Subject: The DOE Position on Drift Collapse

This letter is a follow-up to previous discussion between NRC and CNWRA staff and a summary of CNWRA staff opinion regarding the current DOE position on the long-term stability of emplacement drifts at the proposed Yucca Mountain repository. The DOE position on rockfall and drift collapse can be summarized as follows.

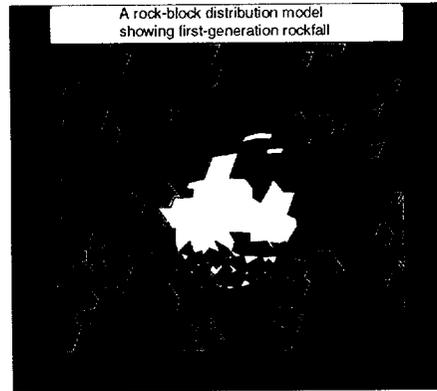
In our opinion, it is unlikely that an acceptable technical basis can be developed to support the current DOE position on drift collapse, which is that the emplacement drifts will not experience significant collapse through the 10,000-year period of regulatory concern. An acceptable case for drift collapse would require information about the potential effects of drift collapse on repository performance. One implication of the DOE position on drift collapse is shown in Figure 1, which is a schematic illustration of the DOE abstraction of moisture flow through the repository horizon. The moisture flux that intersects the drift perimeter (i.e., the deep percolation flux, Q_p) is split into two parts: a part flows around the drift because of the capillarity of the drift opening and the remaining part (q_s) enters the drift opening. The quantities Q_p and q_s are evaluated based on an abstraction of results from process-model calculations that assume a fixed geometry for the emplacement drifts through the entire simulation period. The ratio q_s/Q_p used in DOE's performance assessment (CRWMS M&O, 2000a, Tables 8 and 11) varies with the deep percolation flux, but is generally smaller than 0.05 for values of Q_p of 15 mm/yr or smaller. That is, only 5% or less of the available deep percolation flux may seep into the emplacement drifts in the DOE performance assessment model. The other 95% or more is diverted around the drift because of the capillarity of the drift opening. An examination of Figure 1(b) indicates a serious cause for concern regarding how much of the initial capillary barrier associated with the drift opening can be assumed to be retained following the onset of drift collapse. As Figure 1(b) shows, the collapse of drifts would create several enlarged fracture spaces that would intercept capillary-held moisture and redirect it into the drift. As a result, the applicable values of the ratio q_s/Q_p may be significantly larger than the values used in DOE's performance assessment.

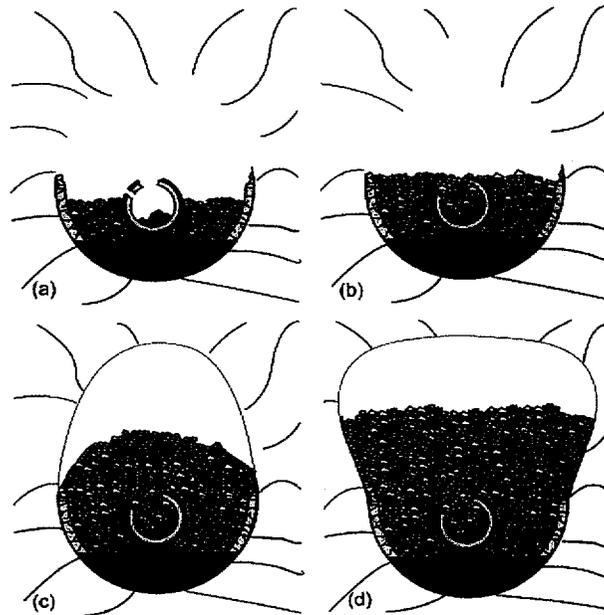
Both the type and degree of drift collapse are likely to vary with time and with rock-mass characteristics as illustrated schematically in Figure 2. For example, the collapsed shapes in Figure 2(b) and (c) may result if collapse is controlled by near-vertical fractures whereas the shape in (d) would result if collapse is controlled by horizontal fractures. The extent of the failure zone and the volume of broken rock that would accumulate in the opening depend on several rock-mass characteristics, such as fracture frequency and orientation, and rock strength. The variability of collapsed-drift characteristics illustrated in Figure 2 indicates that the calculated significance of drift collapse to repository performance would be affected by the assumptions made regarding the timing and rate of drift collapse and the extent of the associated rock failure.
